Contract #: 04-0120F4Cty: SF/ALA Rte: 80 PM: 13.2/13.9File #: 69.25B**QUALITY ASSURANCE -- NON-CONFORMANCE REPORT****Location:** Changxing Island, Shanghai, P.R. China**Report No:** NCR-000312**Prime Contractor:** American Bridge/Fluor Enterprises, a JV**Date:** 06-Jun-2009**Submitting Contractor:** Zhenhua Port Machinery Company, Ltd (ZPMC), Changxing Island**NCR #:** ZPMC-0286**Type of problem:****Welding****Concrete****Other****Welding****Curing****Procedural****Bridge No:** 34-0006**Joint fit-up****Coating****Other****Component:** OBG Crossbeam CB3**Procedural****Procedural****Description:****Reference Description:** Improper Match Marking, Crossbeam CB3**Description of Non-Conformance:**

Job Name: SAS Superstructure
Document No: 05.03.06-000273

Reference Description: Improper Match Marking, Crossbeam CB3

Subject: NCR No. ZPMC-0286

Component: OBG Crossbeam CB3

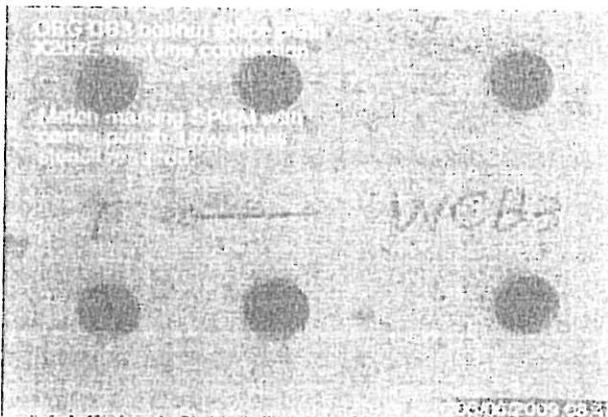
Caltrans Quality Assurance (QA) Inspector observed that the Contractor appears to have stenciled match marking identification numbers on two SPCM splice plates using a center punch rather than the required low stress stencil. Both parts are identified as X202E. Both plates are part of OBG crossbeam CB3. They connect the bottom panel of the crossbeam to the east and west lines.

AWS D1.5 2002 Section 12.4.6: "When heat numbers and other identification markings are applied by die stamping, low-stress dies shall be used."

Reference Resolution: ABF has instructed ZPMC to grind off the punch marks, weld repair if necessary and submit a report documenting the repair.

ABF has instructed ZPMC to grind off the punch marks, weld repair if necessary and submit a report documenting the repair. ZPMC will submit the necessary inspection reports at a later date to close this NCR.

Joint fit-up Coating Other **Component:** OBG Crossbeam CB3

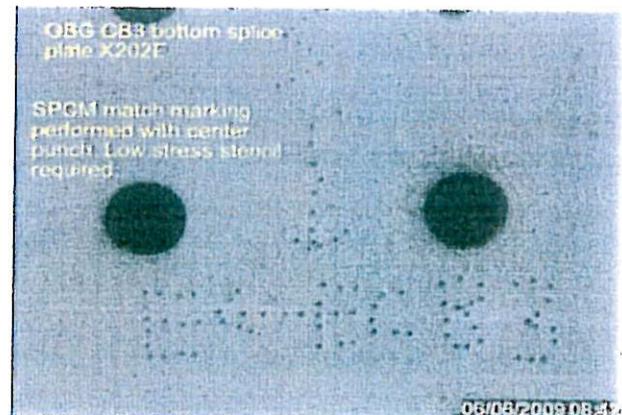
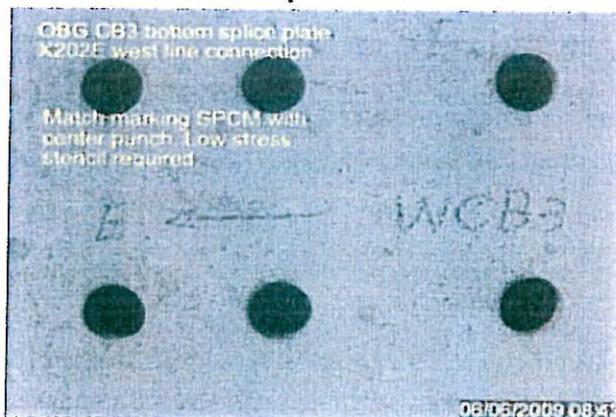
Caltrans Quality Assurance (QA) Inspector observed that the Contractor appears to have stenciled match marking identification numbers on two SPCM splice plates using a center punch rather than the required low stress stencil. Both parts are identified as X202E. Both plates are part of OBG crossbeam CB3. They connect the bottom panel of the crossbeam to the east and west lines.

AWS D1.5 2002 Section 12.4.6: "When heat numbers and other identification markings are applied by die stamping, low-stress dies shall be used."

The proposed resolution is acceptable. The Department has verified that the unacceptable punch marks were ground sufficiently to satisfy the code requirement. The Department concurs that Non-Conformance ZPMC-0286 is closed.
